Project: IEEE P802.15 Working Group for Wireless Personal Area Networks (WPANs)

Submission Title: [DS-UWB Responses to TG3aVoter NO Comments]

Abstract: [Response to NO voter comments and feedback regarding the DS-UWB (Merger #2) Proposal]

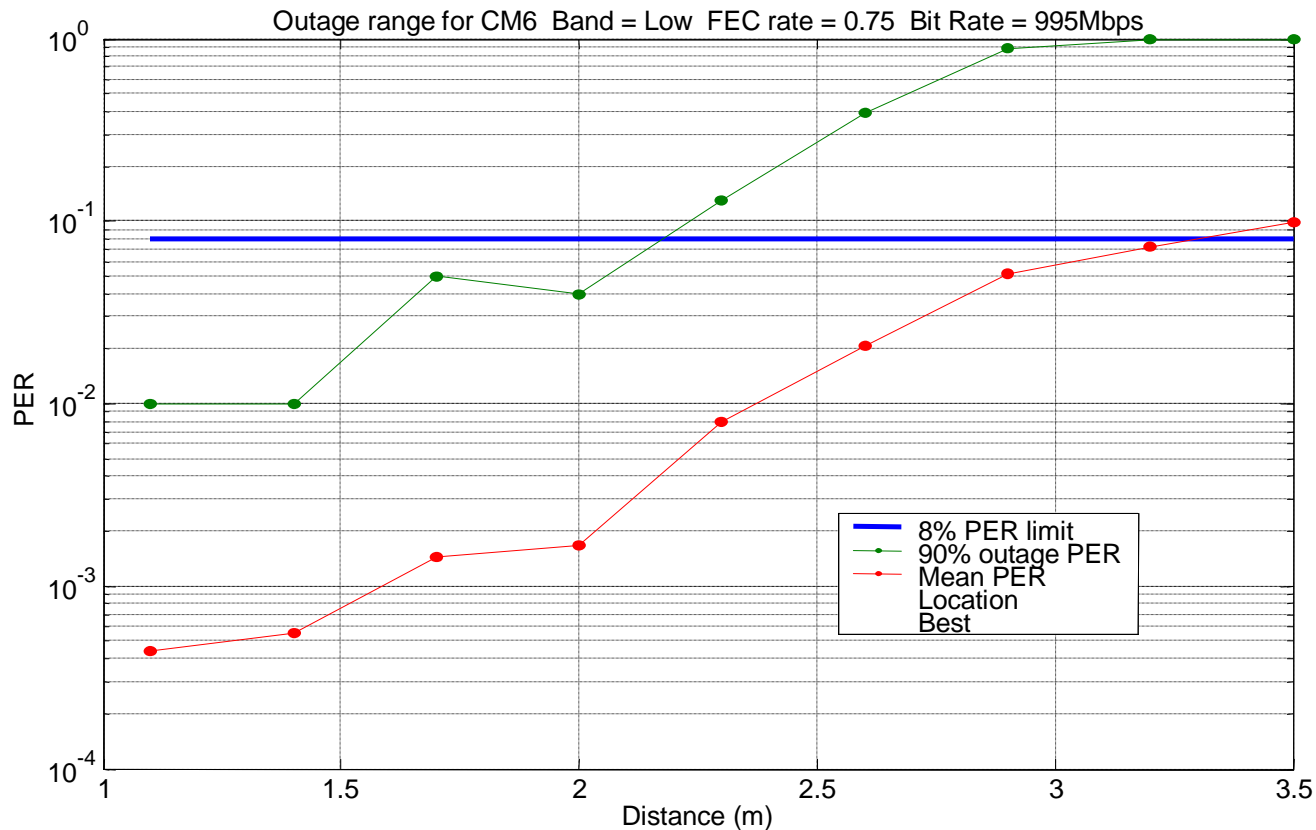
- Comments:
 - “Video links, the primary potential application for link speeds greater than 1Gb are very sensitive to data loss. Claims of high throughput achieved by obscuring the reliability problem are extremely flawed. The willingness of this proposer to put the customer at risk in this manner is highly disturbing. I wish to see the proposer describe their system in terms of usable bandwidth. Below 1Gb, applications can frequently tolerate higher packet error rates stated in the evaluation criteria. Above 1Gb, applications shift to video and need measurements in terms of a 1% packet error rate. To state a 15% rate is absurd and must be stopped.”

- My skepticism about the practicality of the unprotected 1Gbps data rate has been confirmed by recently published simulation results e.g. in 802.15-04-0483r5. For example, CM1 range for low band 1000Mbps on slide 24. Even in the case of no interferers, the packet error rate could not be shown to drop below 39% at any distance. Therefore, the authors have a way to go before they have convincingly shown a path to robust transfer of Gigabytes of information in a real world environment. If this system is to rely on ARQ as has been suggested, then the total system throughput has to be demonstrated in the context of the 15.3MAC MIFS and SIFS times, the bandwidth allocated to ARQ retries, the impact of multiple piconet interference, etc. If such an overall system analysis for Gbps data rates were presented in a convincing way, I would consider changing my no vote to a yes.

- DS-UWB has multiple modes (with FEC) supporting 1+ Gbps (2 bands)
- Simulations in different AWGN and multipath channel conditions
- This is the only proposal considered by TG3a that has demonstrated the capability to satisfy this 1 Gbps requirement from the SG3a CFAs & TG3a Requirements Document
 - No MIMO or higher order modulation (e.g. 16-QAM) is required

Environment	Range	Criteria
AWGN	5.3 m	Mean
Low band CM1	1.7 m	85% Outage
Low band CM1	2.7 m	90% Mean
Low band CM 6* (3 ns RMS delay spread)	2.2 m 3.3 m	90% Outage 90% Mean
High band CM1	2 m	90% Outage
High band CM2	1 m	90% Outage

*CM 6 is a modification of CM1 with 3 ns RMS delay spread – see next slide

- *CM 6 is not a part of the TG3a channel model set, but was developed to quantify performance in channels with lower delay spread than CM1
 - 100 realizations, 3 ns RMS delay spread with 3 dB shadowing standard deviation
 - Intermediate between AWGN channel and CM1 channel (5 ns RMS delay spread)
 - Designed to represent a channel of roughly 0-2 meters with LOS conditions

Example Mask Proposed by ETSI to ITU

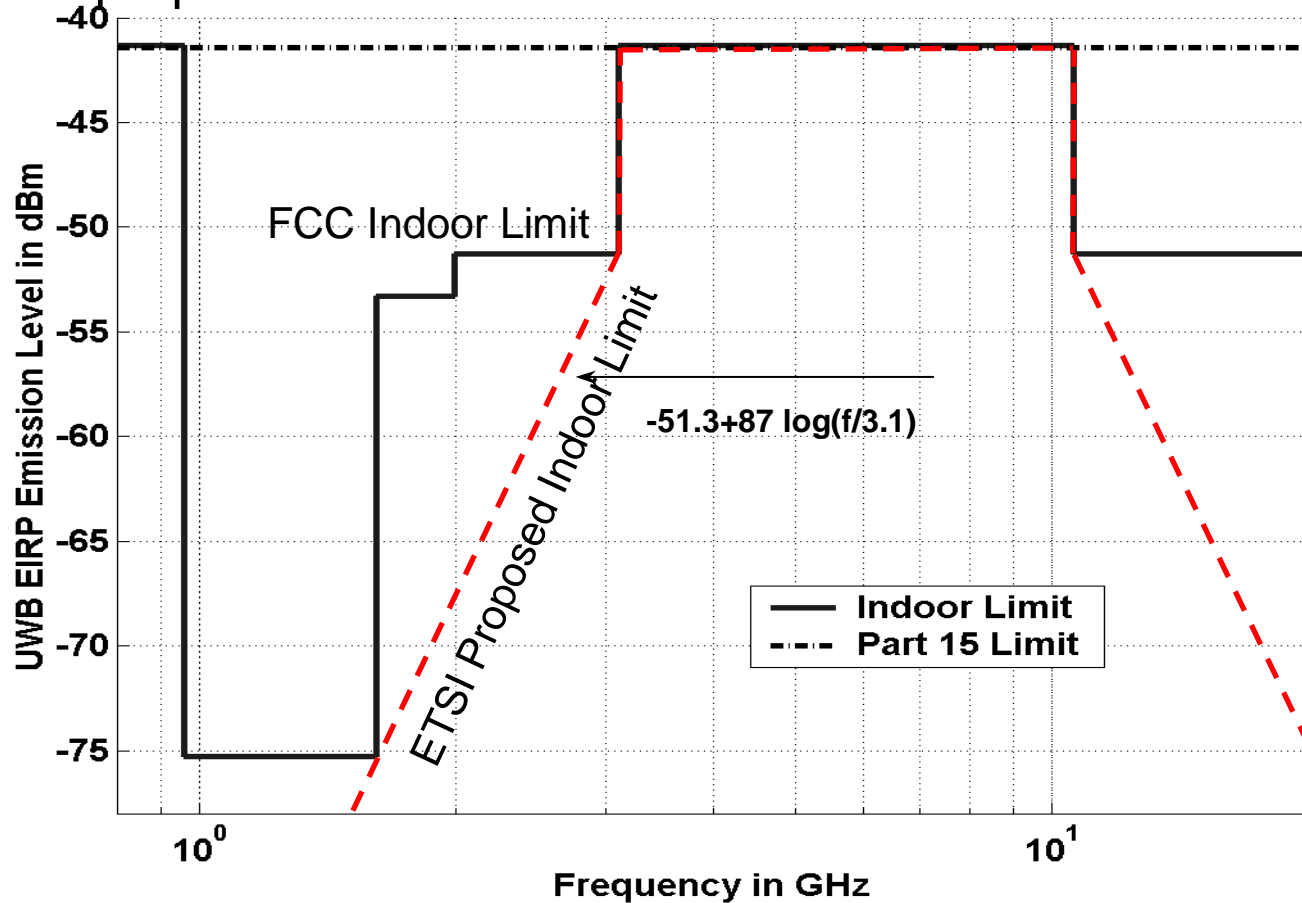
- I would like you to quantify the impact on the DS-UWB system of having to meet strict out of band emissions requirements for services such as IMT-2000 etc. corresponding to proposed protection levels being discussed in ITU-R, etc.

- Lack of an effective mechanism to solve out-of-band and in-band interference for incumbent and future radio service operators is a serious disadvantage with the DS-UWB technology. MBOA has proposed MB-OFDM as a solution to meet both performance and interference mitigation; at present, it is the only one UWB technology that provides a mechanism to coexist with other radio services. As being discussed at ITU-R, CEPT and other regulatory meetings, UWB interference is a global issue, and industry needs a standard solution that meets both performance and interference mitigation. Techniques proposed from DS-UWB in the past either accompany an excessive performance drop or lack technical feasibility. Without an effective technical remedy for DS-UWB, it is extremely difficult to reconsider my NO vote.

Note that the US is not supporting this indoor limit proposed by ETSI
USA has proposed that ITU use the FCC's mask

OOB Emissions: Measurements of MB-OFDM

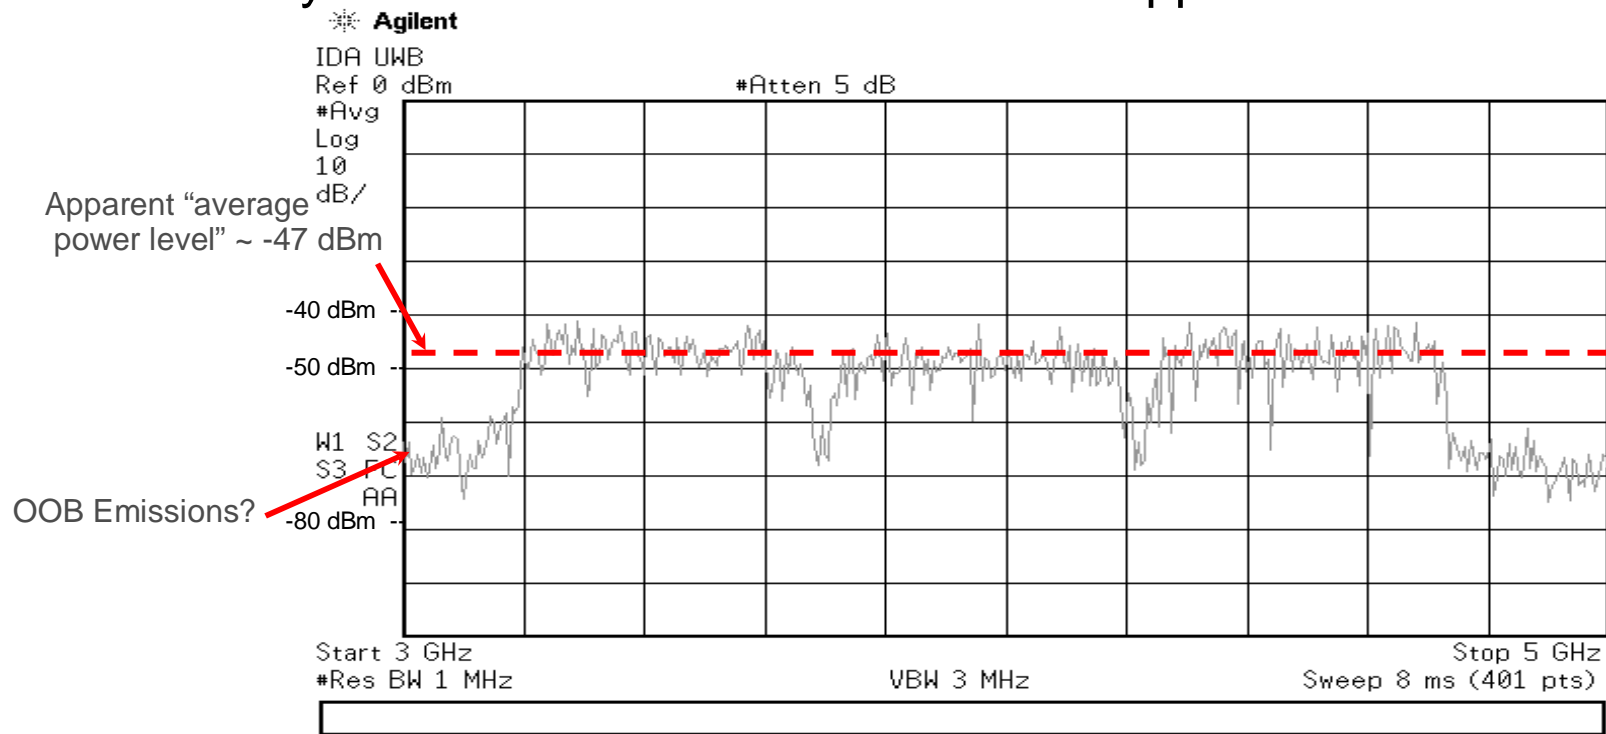
- Commenter indicates that only MB-OFDM can meet OOB emission levels required to coexist with other systems
- Publicly released measurements do not support this conclusion

Figure B-1 below is a spectral plot of the output of the Staccato SC1000D MB-OFDM UWB transmitter captured directly from an Agilent E4407B spectrum analyzer. An RMS detector and a resolution bandwidth (RBW) of 1MHz were used. The plot, which begins at 3GHz and stops at 5GHz, shows the three OFDM bands that make up the signal. Note that the maximum power spectral density of the signal is around -41dBm/MHz.

Simple Example of Pulse Shaped to Create a Notch

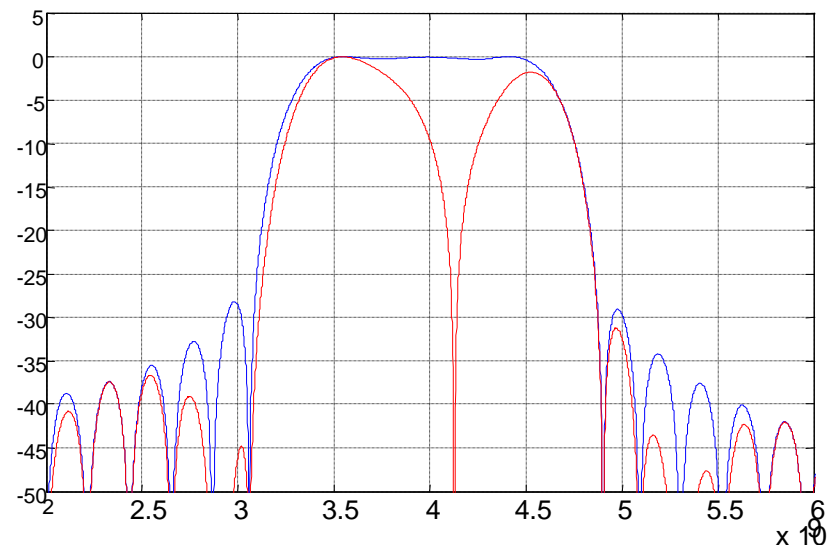
- Comments
 - Any attempt to change the spectrum will generate ISI which will make the equalizer problem even worse
 - Spectral shaping of DSSS introduces ICI and rapidly degrades performance
 - This pulse shaping will also severely degrade the performance
- Response:
 - Pulse shaping lengthens the pulse only marginally
 - A well-designed receiver is already designed to tolerate channel dispersion of 50+ ns and is relatively insensitive to pulse shape – the notch looks like part of the channel
 - Conclusion: Pulse shaping does not cause unmanageable ICI or ISI

- Pulse shaping lengthens the pulse only marginally
- A well-designed receiver is already designed to tolerate channel dispersion of 50+ ns and is relatively insensitive to pulse shape – the notch looks like part of the multipath channel
- Conclusion: Pulse shaping does not cause unmanageable ISI

ADC Complexity

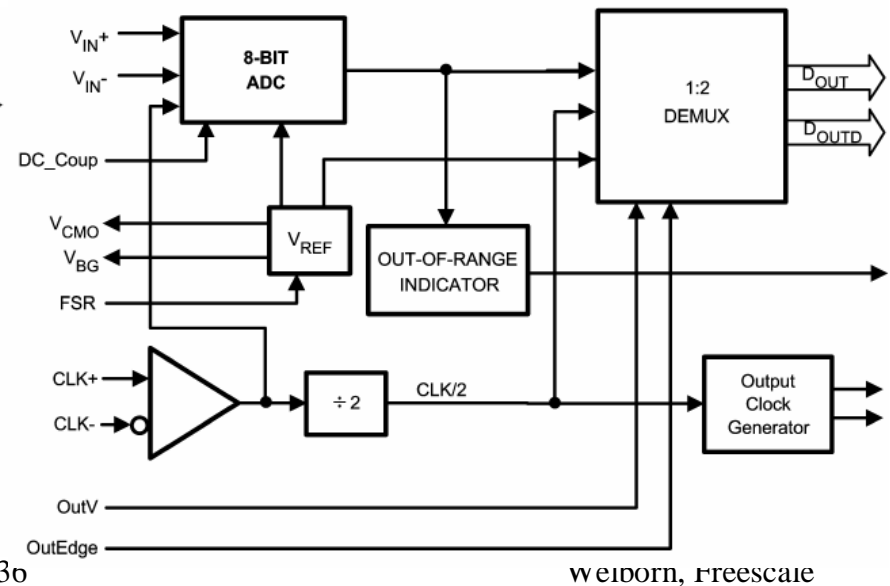
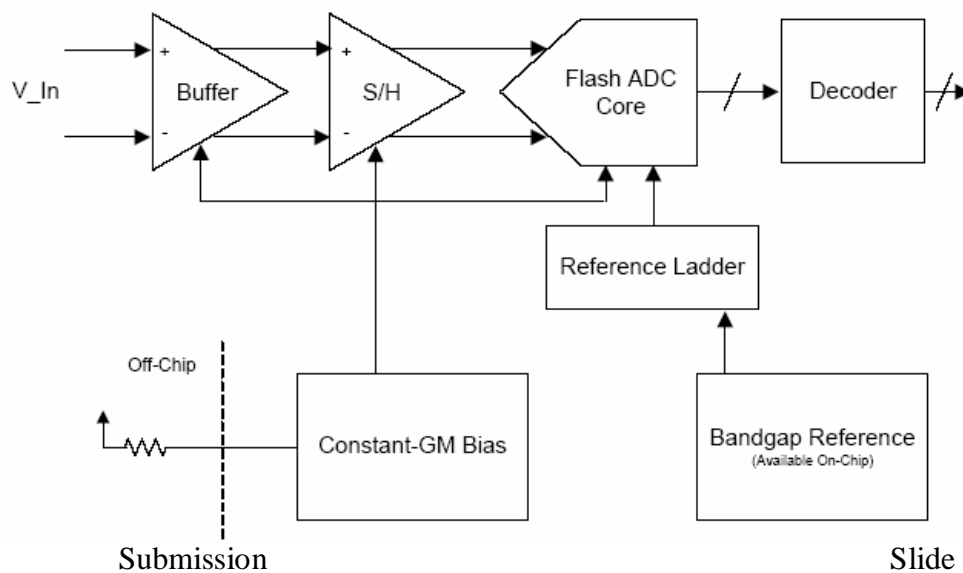
- Comment:
 - The ADC speed and amplifier quality seem to dictate implementation in an exotic process, which in my humble opinion would place a significant damper on adoption. Selecting a standard with significant adoption hurdles will encourage fragmentation of the medium, as lower-cost, higher performance technologies pass by the standard.
- Resolution:
 - ADCs at speeds and quality requires for DS-UWB are already available in commercial products

ADC in 0.13 CMOS ~ 50mw 3-bits 2.5 Gsps

Snowbush Microelectronics ADC8005

- 6-bits - ENOB: 5.2 bits at Nyquist
- DNL at +/- 0.5 LSB, INL at +/- 1.0 LSB
- Input dynamic range: +/-0.4V differential
- Analog bandwidth: 5GHz
- Single 1.2V power supply
- Power dissipation: 500mW
- Input capacitance: 150fF single-ended
- Sophisticated digital error correction
- Designed in a 0.13um TSMC CMOS process

- ## National Semi ADC081000
- 8-Bit, 1 GSPS A/D .18 CMOS
 - ENOB @ 500 MHz Input 7.5 Bits (typ)
 - Operating 1.45 W (typ)
 - Scale to 3-bits ~ 45mw
 - Power Down Mode 9 mW (typ)
 - Single +1.9V ±0.1V Operation
 - Guaranteed No Missing Codes
 - DNL ±0.25 LSB (typ)
